SUBJECT: Resolution 19-025: Resolution Recommending the City Council Approve/Deny a variance
Garage Door Height Belle Plaine Schools ISD 716

ISD 716 Garage Door Height Variance

**BELLE PLAINE SCHOOL K12
GARAGE - STORAGE - RESTROOM ADDITION
BELLE PLAINE, MINNESOTA**

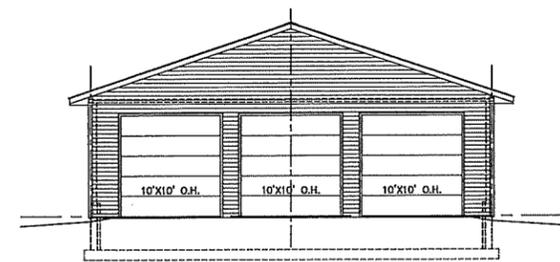
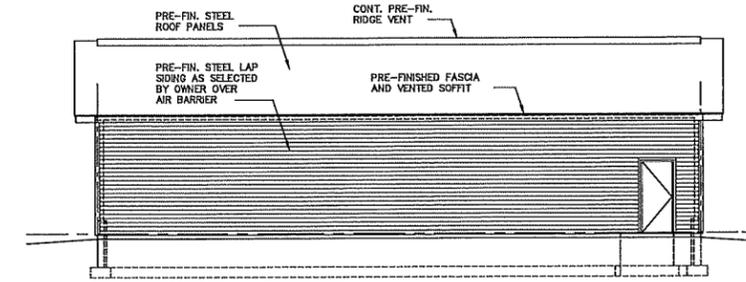
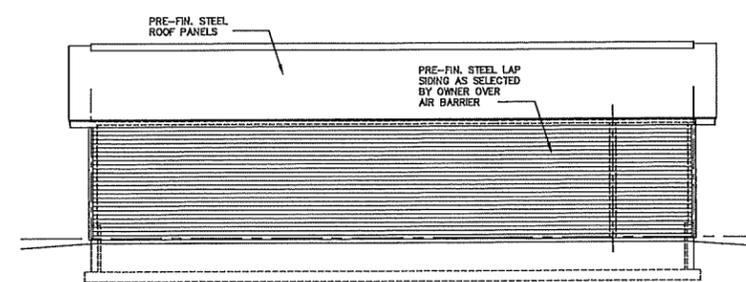
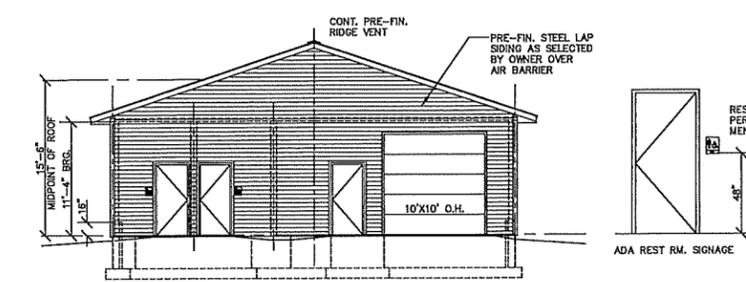
Belle Plaine Schools proposes construction of a 2,400 square foot facility on Lot 1, Block 5, Belle Plaine School Plat. The facility will be used to house district buses and include restrooms. ISD 716 requests consideration of a variance to maximum garage door height in the R-3 District to allow four (4) garage doors which are ten (10) feet in height. Building elevations are attached.

Section 1105.07, Subd. 6(3) of the Code establishes a maximum garage door height of nine (9) feet. A height of ten (10) feet is requested, a variance of one foot.

- The subject property is guided for residential use and zoned R-3 Single and Two Family Residential. Educational uses are allowable uses in the R-3 District. Use of the property will remain educational. Buses are a typical part of school operations. The proposed facility is consistent with Comprehensive Plan and the general purpose/intent of the Code.
- The proposed facility is to be located south of an existing off-street parking area and west of an existing school. There are no residential dwellings contained within the vicinity of the proposed facility.
- Buses to be stored in the facility require a ten-foot overhead door clearance, without the variance the school must store buses outside.

- The plight of the property owner results from the fact the property owner operates school buses and is not unique to the property.
- The plight of the property owner is not related to lot shape, size, features, or any naturally occurring factor. The height of a garage door is not unique to the property and could occur in nearly any area within the City zoned R-3 Single and Two Family Residential.

Staff recommends approval of a variance to Section 1105.07, Subd. 6(3) thereby allowing a ten (10) foot garage door height.
